Form 3160-5
(August, 2007)UNITED STATES
DEPARTMENT OF THE INTERIOR
BUREAU OF LAND MANAGEMENT

**TUBING CHANGE OUT AND/OR
PLUG AND ABANDONMENT PROCEDURE**

Lybrook 004-22

Re: Permanent Abandonment
Well: 4 Lybrook 22

Proposed P&A

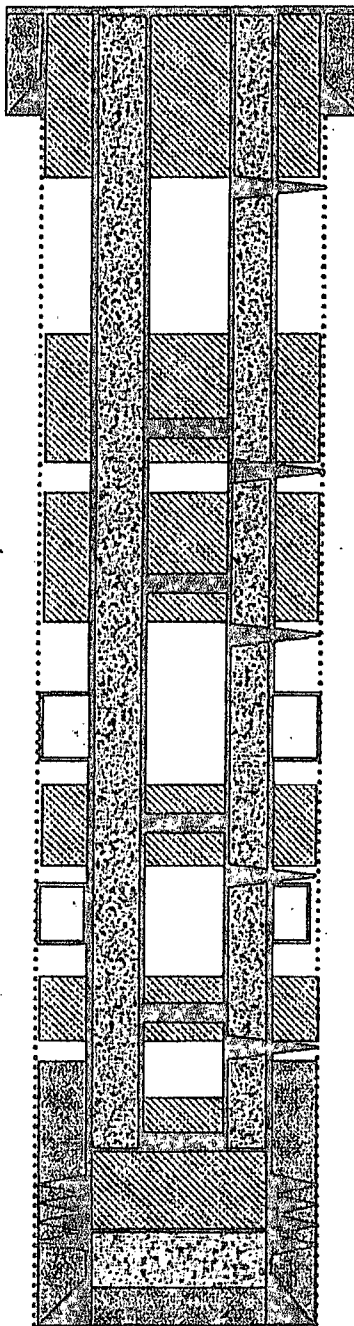
1. Plugging operations authorized are subject to the attached "General Requirements for Permanent Abandonment of Wells on Federal and Indian Lease."
2. Farmington Office is to be notified at least 24 hours before the plugging operations commence (505) 564-7750.
3. The following modifications to your plugging program are to be made:
 - a) Place the Measverde plug from 2904' – 2804'.
 - b) Place the Pictured Cliffs/Fruitland plug from 2080' – 1766' inside 2 7/8" and outside the 4 1/2" casings.
 - c) Place the Kirtland/Ojo Alamo plug from 1610' - 1342' inside 2 7/8" and outside the 4 1/2" casings.

You are also required to place cement excesses per 4.2 and 4.4 of the attached General Requirements.
